Road Safety Audit Stage 1

Crossley Lane, Dalton, Kirklees – Road Safety Audit Stage 1

2025-09 Dalton RSA1 – Revision 0

Problem Location Plan

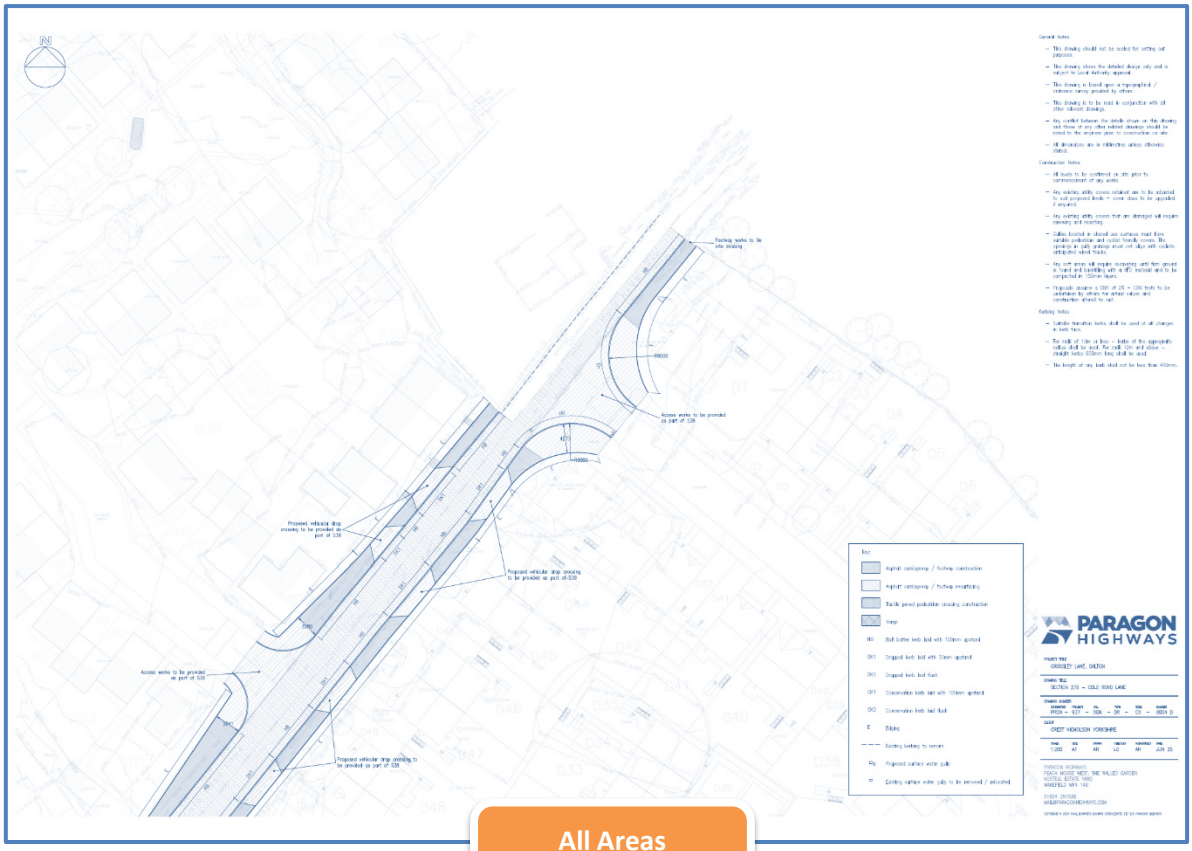
PROBLEM – A-01

Summary: Drainage – Ineffective drainage of surface water may increase the risk of skidding or loss of control type collisions.

At this early stage, drainage details may not have been considered. It was noted that the development will be generally level but will have a number of features that may trap surface water such as dropped crossings and new junctions. This may increase the risk of standing surface water on the carriageway and in crossing points with detritus buildup in these areas. This may consequently cause skidding type collisions or slips and falls by pedestrians using these areas which can be life changing, especially for older pedestrians.

PROBLEM – A-02

Summary: Network Management – Increased on-street parking may increase the risk of collisions involving pedestrians and other active mode users or junction related collisions.

The proposals introduce a pedestrian refuge and crossing points on an established residential frontage as well as a second pedestrian refuge and new junctions on what will become a new residential frontage. On-street parking along these roads is likely to increase and may, in some locations, obscure the crossing or junction visibility. This may increase the risk of collisions involving pedestrians and other active mode users or junction related collisions.

PROBLEM – A-03

Summary: Specific Road Users – Lack of crossing facility may increase the risk of collisions involving users who rely on mobility aids.

There is a desire line along the northern footway of Crossley Lane where no provision has been made for pedestrians with mobility issues, specifically those users with prams, wheelchairs or mobility scooters. The alternatives for these users may require them to use drop kerbs provided for driveways or to cross at locations where visibility to approaching vehicles may be otherwise compromised. This lack of dropped crossings on desire lines may increase the risk of collisions involving users with mobility issues.

PROBLEM – A-04

Summary: Specific Road Users – Lack of crossing facility may increase the risk of collisions involving users who rely on mobility aids.

There is a desire line to cross Crossley Lane where no provision has been made for pedestrians with mobility issues, specifically those users with prams, wheelchairs or mobility scooters. The alternatives for these users may require them to use drop kerbs provided for driveways or to cross at locations where visibility to approaching vehicles may be otherwise compromised. This lack of dropped crossings on desire lines may increase the risk of collisions involving users with mobility issues.

PROBLEM – A-05

Summary: Cycles – Width provision for cycles may increase the risk of shunt or side swipe type collisions involving this user group.

Details of kerb-to-kerb widths have been provided at the proposed refuges. At these locations, cyclists are at risk on the main carriageway from vehicles passing too close due to a potential ambiguity of width as they overtake the slower moving cyclist. Incompatible width provision for cyclists may increase the risk of shunt or side swipe type collisions involving this user group.

PROBLEM – A-06

Summary: Lighting – Insufficient carriageway surface illumination may increase the risk of collisions involving pedestrians during the hours of darkness.

There is currently street lighting provision in the vicinity of the proposed pedestrian crossing points along Crossley Lane. This is likely to provide a standard level of carriageway illumination for a commercial frontage. The introduction of dropped crossings will focus pedestrians to cross at these locations where pedestrians and other active mode users may not have enough contrast against background light from the adjacent development and vehicle headlights. Insufficient carriageway surface illumination at the crossing points may increase the risk of collisions involving pedestrians and other active mode users during the hours of darkness.

It is recommended that all areas are provided with suitable surface water drainage measures to minimise the risk of standing water and detritus. It is also recommended that details of these are provided at the next stage of road safety audit including gully locations, levels and contours.

It is recommended that the scope for waiting restrictions near key junctions and pedestrian refuges is established and, where necessary, provided.

It is recommended that a dropped pedestrian crossing with (ideally) tactile paving is provided across Cold Royd Lane.

It is recommended that a dropped pedestrian crossing with (ideally) tactile paving is provided across Crossley Lane towards the eastern end of the development.

It is recommended, as per advice in LTN 1/20 Chapter 7, that widths between 3.1m and 3.9m may encourage close overtaking by motor vehicles at pinch points and should be avoided.

It is recommended that carriageway surface illumination is provided to a higher class/level in the vicinity of the proposed crossing points. This may be as simple as increasing the output from the existing LED luminaries.
